H. B. ROBINSON STEAM ELECTRIC PLANT, UNIT NO. 2

AMENDMENT TO FACILITY OPERATING LICENSE

Amendment No. 92  
License No. DPR-23

ATTACHMENT TO LICENSE AMENDMENT

H.B. ROBINSON UNIT #2  
 Carolina Power & Light Company  
 FINAL SAFETY ANALYSIS REPORT  
 FACILITY ORGANIZATION  
 ROBINSON NUCLEAR PROJECT  
 Figure 6.2-2

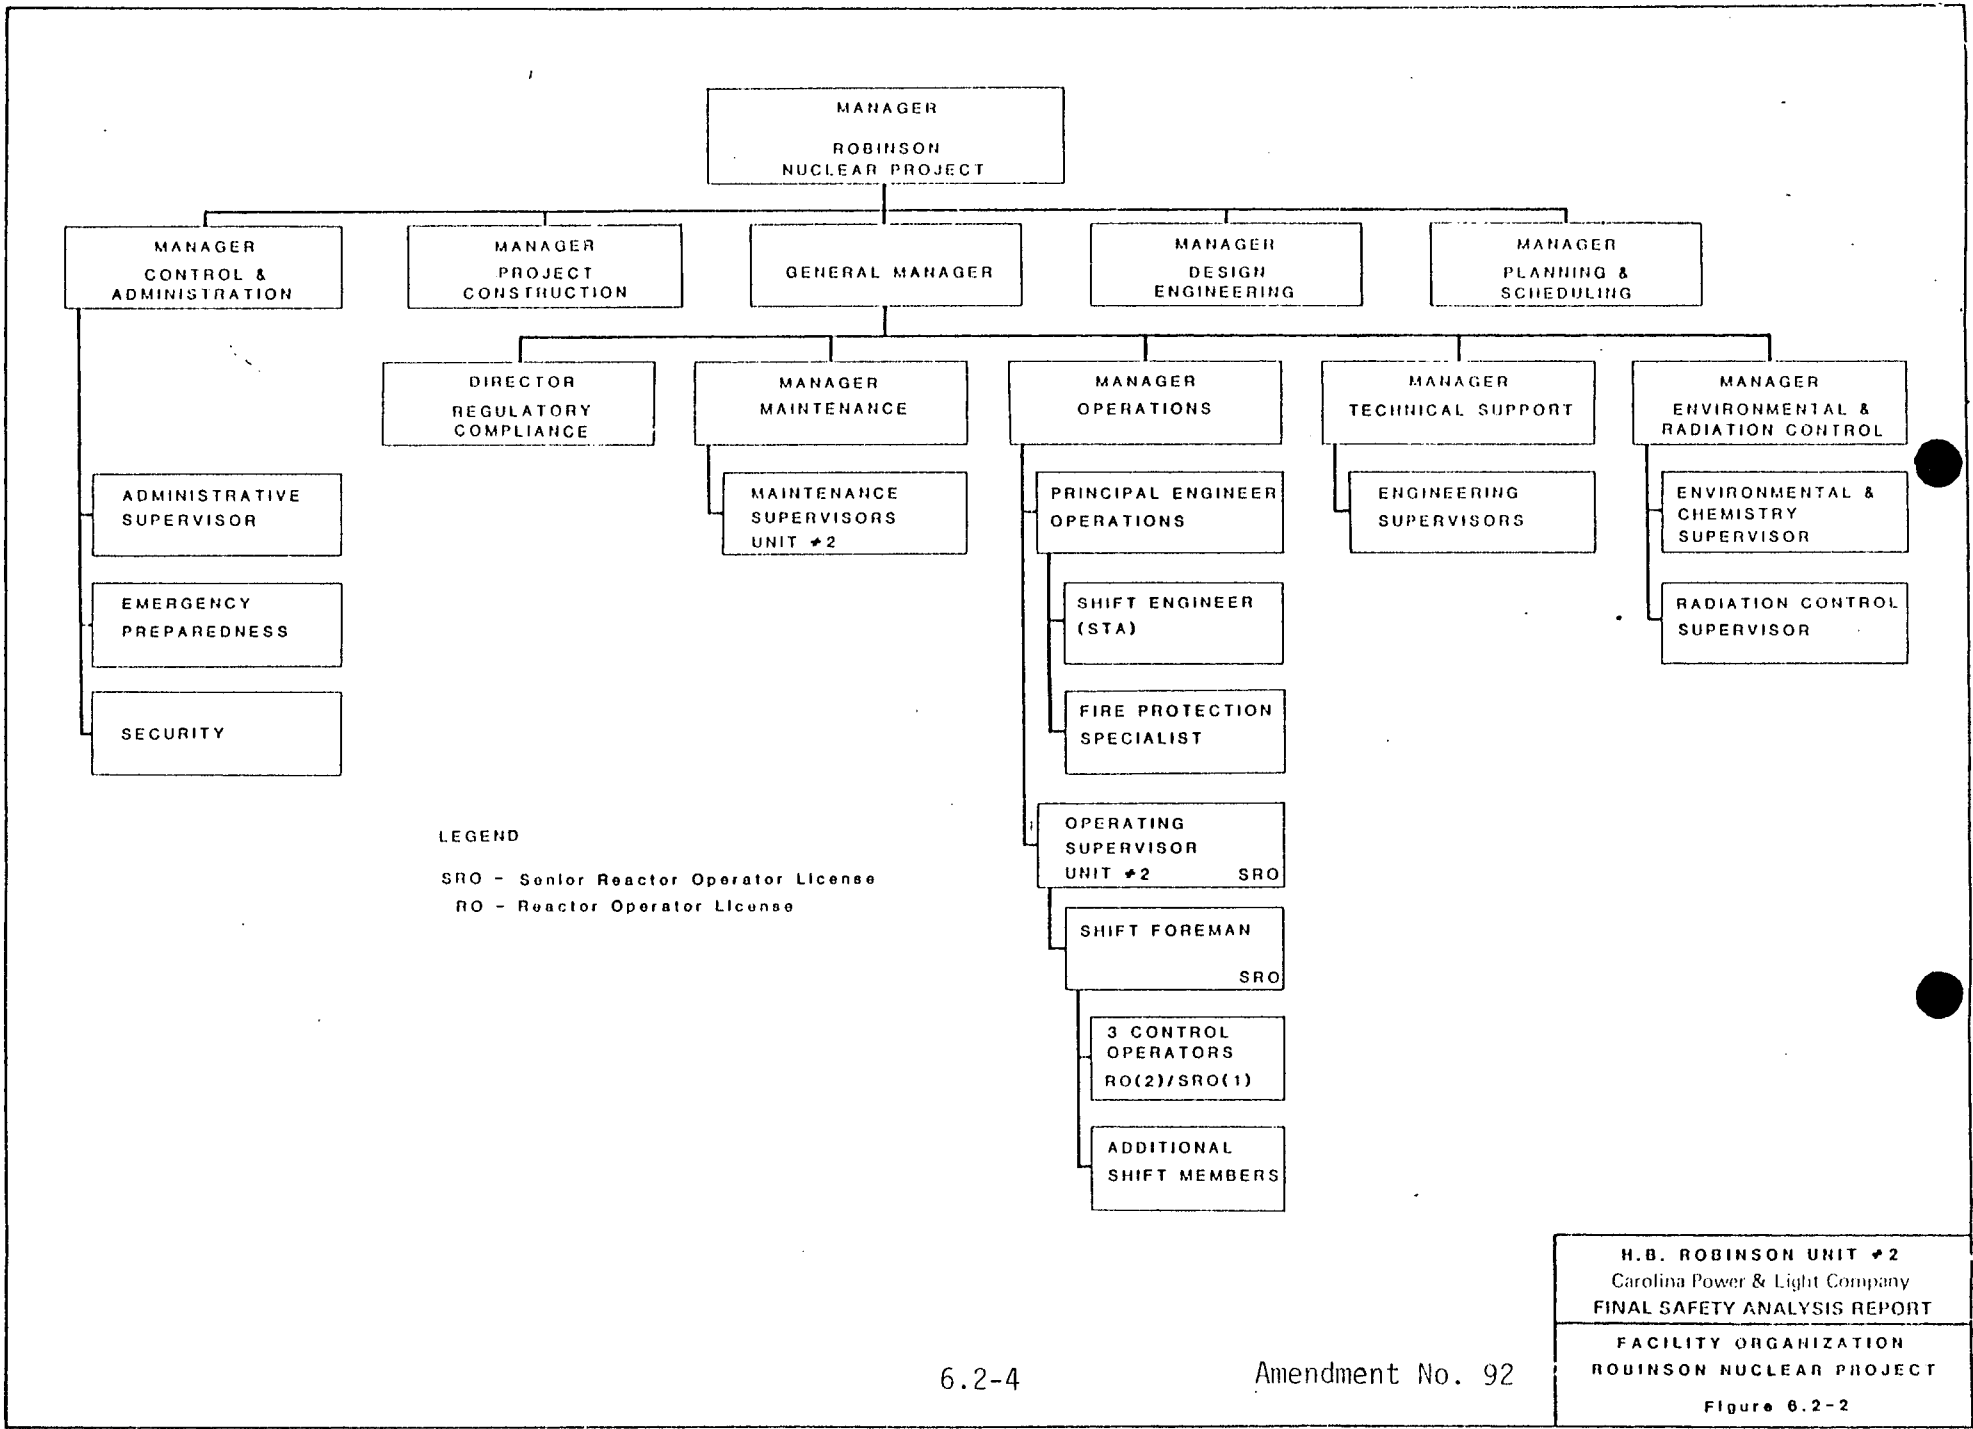
<u>Remove Pages</u>	<u>Insert Pages</u>
6.2-4	6.2-4
6.4-1	6.4-1
6.5-6	6.5-6
